GC0151 WAGCM2 Alternative Proposal Legal Text

Proposed changes legal text in CC

Proposed changes legal text in ECC

Figure CC.6.3.15(a)(i)(a)

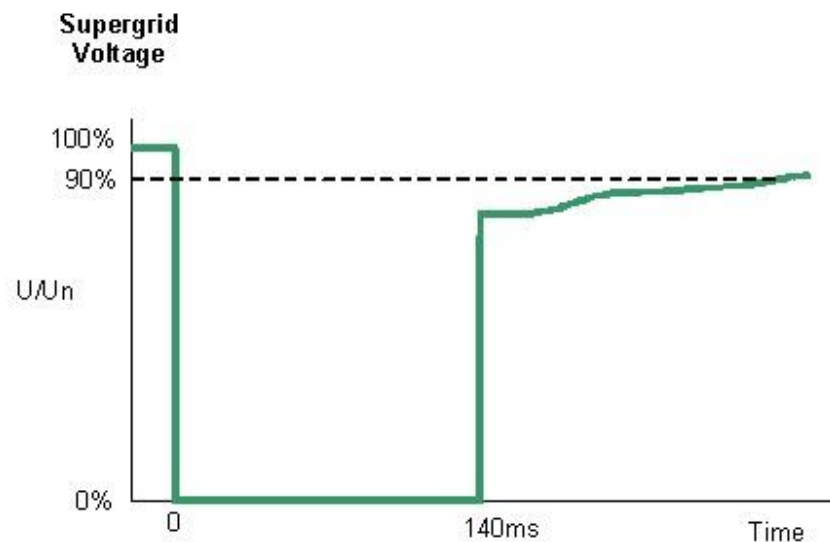
- (i)(a) Each **Generating Unit, DC Converter, or Power Park Module** and any constituent **Power Park Unit** thereof and **OTSDUW Plant and Apparatus** shall **be designed to** remain transiently stable and connected to the **System** without tripping of any **Generating Unit, DC Converter or Power Park Module** and / or any constituent **Power Park Unit, OTSDUW Plant and Apparatus**, and for **Plant and Apparatus** installed on or after 1 December 2017, reactive compensation equipment, for a close-up solid three-phase short circuit fault or any unbalanced short circuit fault on the **Onshore Transmission System** (including in respect of **OTSDUW Plant and Apparatus**, the **Interface Point**) operating at **Supergrid Voltages** for a total fault clearance time of up to 140 ms. A solid three-phase or unbalanced earthed fault results in zero voltage on the faulted phase(s) at the point of fault. The duration of zero voltage is dependent on local **Protection** and circuit breaker operating times. **Where The Company or Transmission Owner have agreed the duration of zero voltage** and the fault clearance times **are less than 140ms this** will be specified in the **Bilateral Agreement**. Following fault clearance, recovery of the **Supergrid Voltage** on the **Onshore Transmission System** to 90% may take longer than 140ms as illustrated in Figure CC.6.3.15(a)(i)(a) and Appendix 4A Figures CC.A.4A.1 (a) and (b).

(i)(b) Each **Generating Unit, DC Converter, or Power Park Module** and any constituent **Power Park Unit** thereof and **OTSDUW Plant and Apparatus** shall remain transiently stable and connected to the **System** without tripping of any **Generating Unit, DC Converter or Power Park Module** and / or any constituent **Power Park Unit, OTSDUW Plant and Apparatus**, and for **Plant and Apparatus** installed on or after 1 December 2017, reactive compensation equipment, for any balanced and unbalanced fault where subjected to a voltage dip at either the **Onshore Grid Entry Point** or **Interface Point** as applicable where the voltage remains either on or within the envelope shown in figure CC.6.3.15(a)(i)(a) except where:

Figure CC.6.3.15(b)

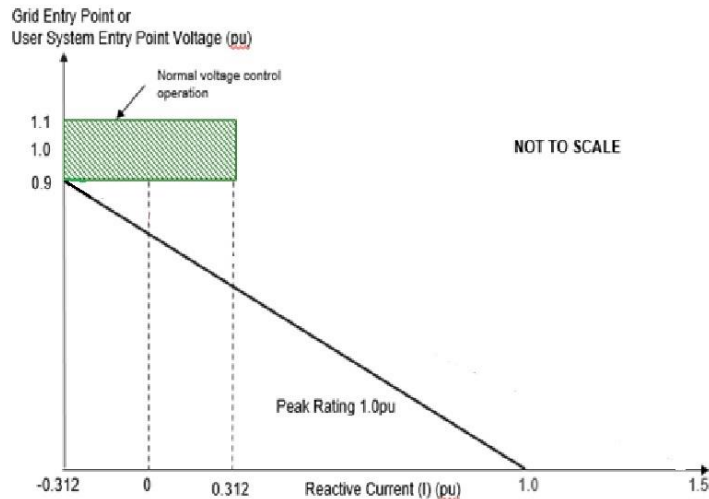
- (iii) During the period of the fault as detailed in CC.6.3.15.1 (a) (i)(a) for which the voltage at the **Grid Entry Point** (or **Interface Point** in the case of **OTSDUW Plant and Apparatus**) is outside the limits specified in CC.6.1.4, each **Generating Unit or Power Park Module or OTSDUW Plant and Apparatus** shall ~~generate maximum reactive current~~ **inject a reactive current above the heavy black line shown in Figure CC.6.3.15(b)** without exceeding the transient rating limit of the **Generating Unit, OTSDUW Plant and Apparatus or Power Park Module** and / or any constituent **Power Park Unit** or reactive compensation equipment.

For **Plant and Apparatus** installed on or after 1 December 2017, switched reactive compensation equipment (such as mechanically switched capacitors and reactors) shall be controlled such that it is not switched in or out of service during the fault but may act to assist in post fault voltage recovery.

Figure 5a

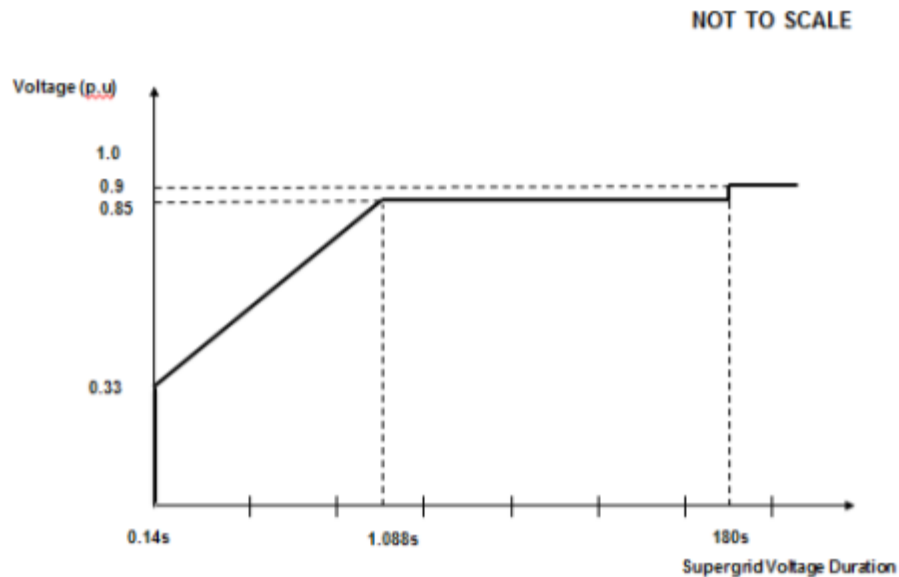
- (i) remain transiently stable and connected to the **System** without tripping of any **Synchronous Generating Unit** for balanced **Supergrid Voltage** dips and associated durations on the **Onshore Transmission System** (which could be at the **Interface Point**) anywhere on or above the heavy black line shown in Figure 5a. Appendix 4A and Figures CC.A.4A.3.2 (a), (b) and (c) provide an explanation and illustrations of Figure 5a; and,

Figure 5b

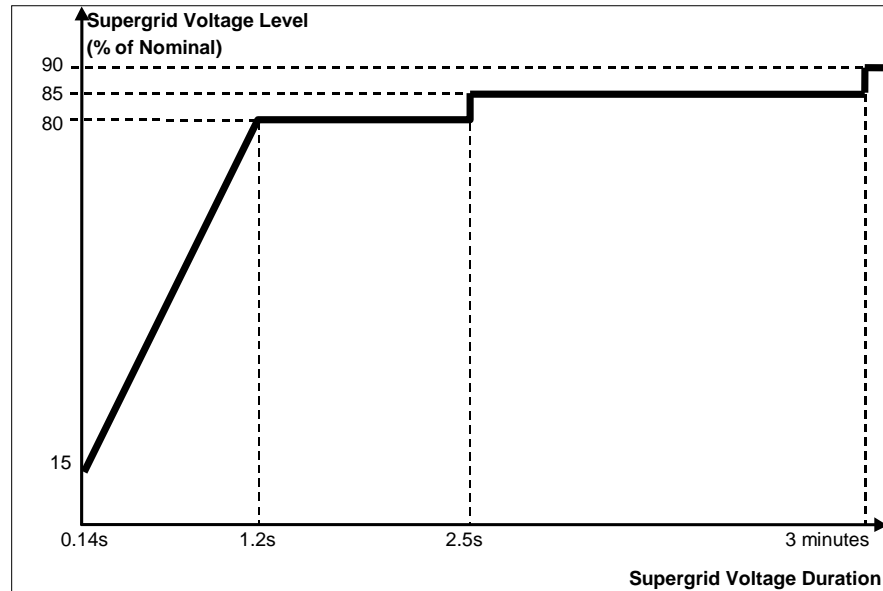
- (i) remain transiently stable and connected to the **System** without tripping of any **OTSDUW Plant and Apparatus**, or **Power Park Module** and / or any constituent **Power Park Unit**, for balanced **Supergrid Voltage** dips and associated durations on the **Onshore Transmission System** (which could be at the **Interface Point**) anywhere on or above the heavy black line shown in Figure 5b. Appendix 4A and Figures CC.A.4A.3.4 (a), (b) and (c) provide an explanation and illustrations of Figure 5b; and,

Figure 6

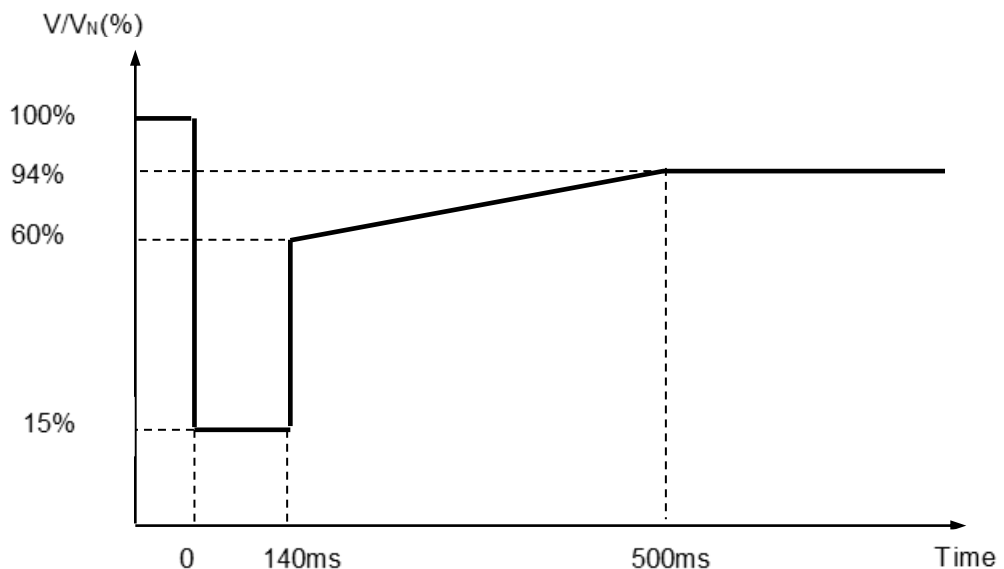
compensation equipment, for any balanced or unbalanced voltage dips on the **LV Side of the Offshore Platform** whose profile is anywhere on or above the heavy black line shown in Figure 6. For the avoidance of doubt, the profile beyond 140ms in Figure 6 shows the minimum recovery in voltage that will be seen by the generator following clearance of the fault at 140ms. Appendix 4B and Figures CC.A.4B.2 (a) and (b) provide further illustration of the voltage recovery profile that may be seen. It should be noted that in the case of an **Offshore Generating Unit, Offshore DC Converter or Offshore Power Park Module** (including any **Offshore Power Park Unit** thereof) which is connected to an **Offshore Transmission System** which includes a **Transmission DC Converter** as part of that **Offshore Transmission System**, the **Offshore Grid Entry Point** voltage may not indicate the presence of a fault on the **Onshore Transmission System**. The voltage dip will affect the level of **Active Power** that can be transferred to the **Onshore Transmission System** and therefore subject the **Offshore Generating Unit, Offshore DC Converter or Offshore Power Park Module** (including any **Offshore Power Park Unit** thereof) to a load rejection.

Figure 7b

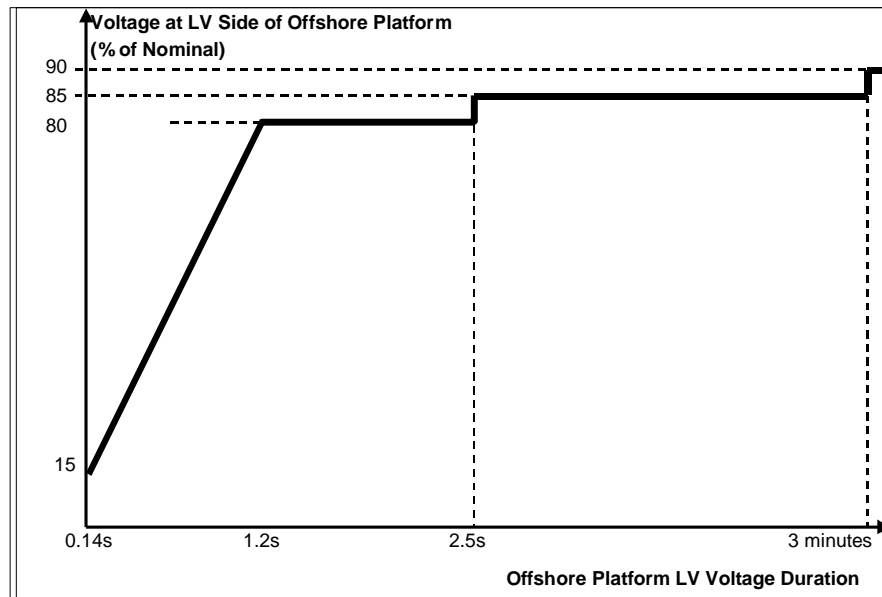
- (i) remain transiently stable and connected to the **System** without tripping of any **Offshore Power Park Module** and / or any constituent **Power Park Unit**, for any balanced voltage dips on the **LV side of the Offshore Platform** and associated durations anywhere on or above the heavy black line shown in Figure 7b. Appendix 4B and Figures CC.A.4B.5. (a), (b) and (c) provide an explanation and illustrations of Figure 7b. It should be noted that in the case of an **Offshore Power Park Module** (including any **Offshore Power Park Unit** thereof) which is connected to an **Offshore Transmission System** which includes a **Transmission DC Converter** as part of that **Offshore Transmission System**, the **Offshore Grid Entry Point** voltage may not indicate the presence of a voltage dip on the **Onshore Transmission System**. The voltage dip will affect the level of **Active Power** that can be transferred to the **Onshore Transmission System** and therefore subject the **Offshore Power Park Module** (including any **Offshore Power Park Unit** thereof) to a load rejection.

Figure ECC.6.3.15.9(a)

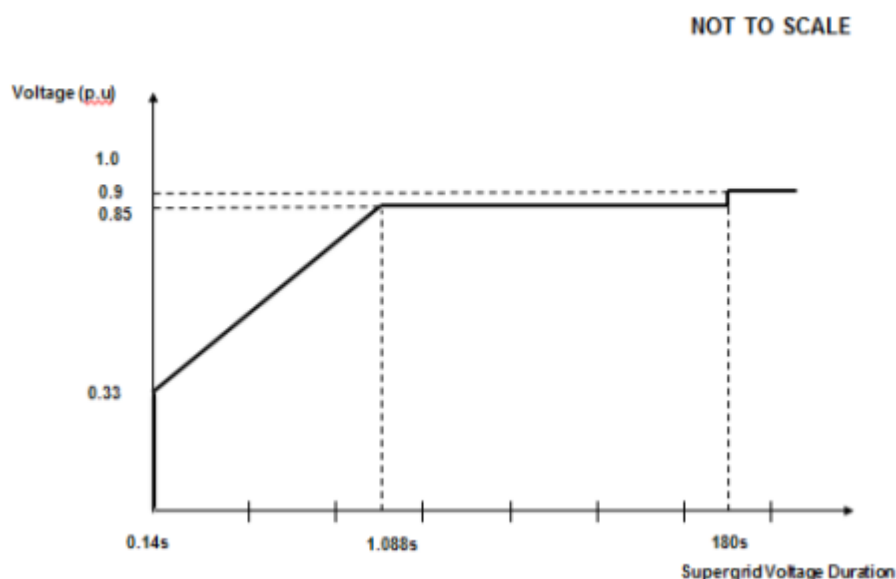
- (i) remain transiently stable and connected to the **System** without tripping of any **Synchronous Power Generating Module** for balanced **Supergrid Voltage** dips and associated durations on the **Onshore Transmission System** (which could be at the **Interface Point**) anywhere on or above the heavy black line shown in Figure ECC.6.3.15.9(a) Appendix 4 and Figures EA.4.3.2(a), (b) and (c) provide an explanation and illustrations of Figure ECC.6.3.15.9(a); and,

Figure ECC.6.3.15.9(c)

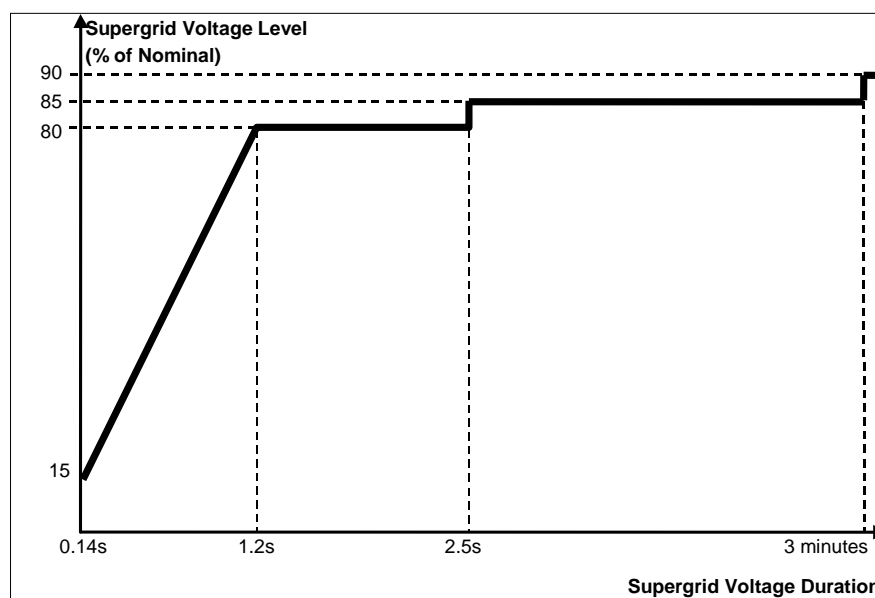
- (i) remain transiently stable and connected to the **System** without tripping of any **OTSDUW Plant and Apparatus**, or **Power Park Module** and / or any constituent **Power Park Unit**, for balanced **Supergrid Voltage** dips and associated durations on the **Onshore Transmission System** (which could be at the **Interface Point**) anywhere on or above the heavy black line shown in Figure ECC.6.3.15.9(c). Appendix 4 and Figures EA.4.3.4 (a), (b) and (c) provide an explanation and illustrations of Figure ECC.6.3.15.9(c) ; and,
